Subject: Notification of a Class 1 Permit Modification to the Hazardous Waste Facility Permit, Number: NM4890139088-TSDF, Entitled Addition of a Roof to the Parking Area Container Storage Unit

Construction of a Roof Within the Parking Area Container Storage Unit

WIPP HWFP #NM4890139088-TSDF

Figure F-1
WIPP Surface Structures

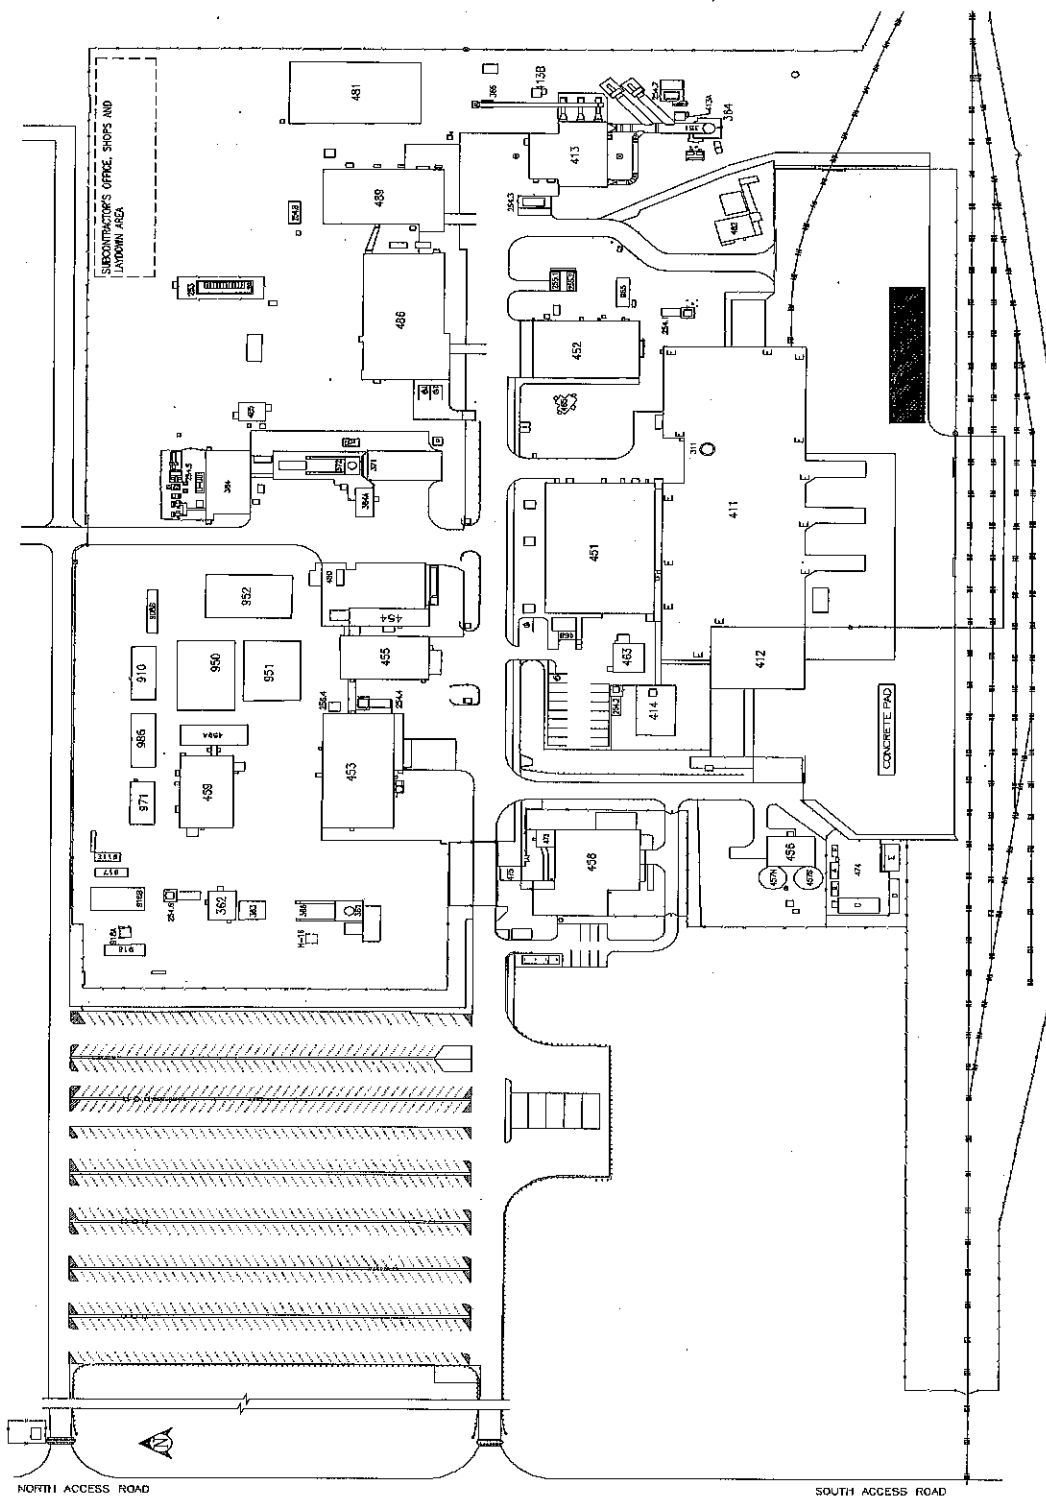
- a. 1. Figure F-1 has been revised
- a.2 Figure F-6 has been revised
- a.3 Figure F-8 has been revised
- b.1 Figure G-2 has been revised
- c.1 Figure M1-2 has been revised
- d.1 Figure O3-4 has been revised

(The PAU roof is indicated on the figures as a rectangle in the southeast corner of the PAU)

Parking Area Unit - Roof

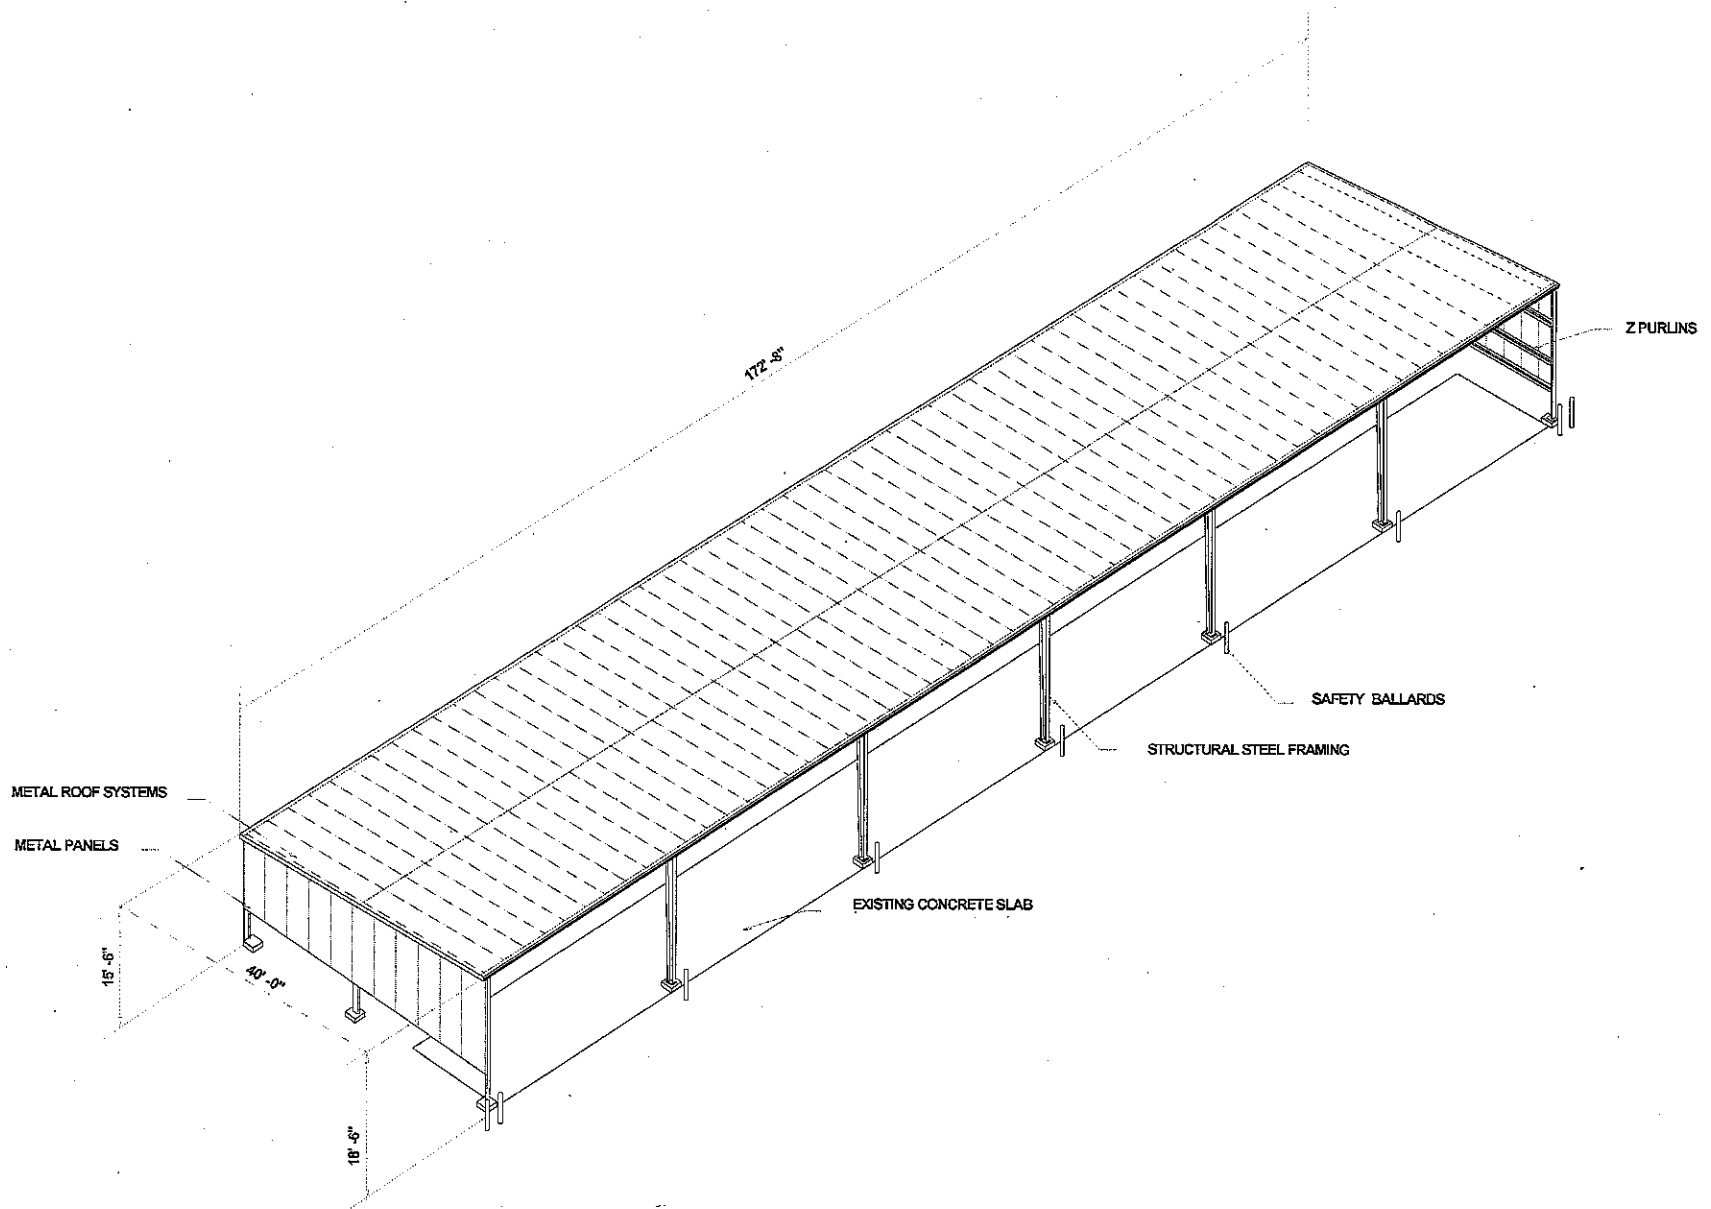
The roof will be approximately 170 feet in length, approximately 40 feet deep which is the length of the existing concrete pad in the PAU. The roof will be approximately 19 feet high to accommodate a trailer with TRUPACT-IIs. Tractors, trailers, empty and loaded CH Packages, forklifts, and other equipment currently used in the PAU may be stored under the roof structure. A diagram of the roof is included in Attachment B of this PMN. The "as built" drawings will be included in the Operating Record.
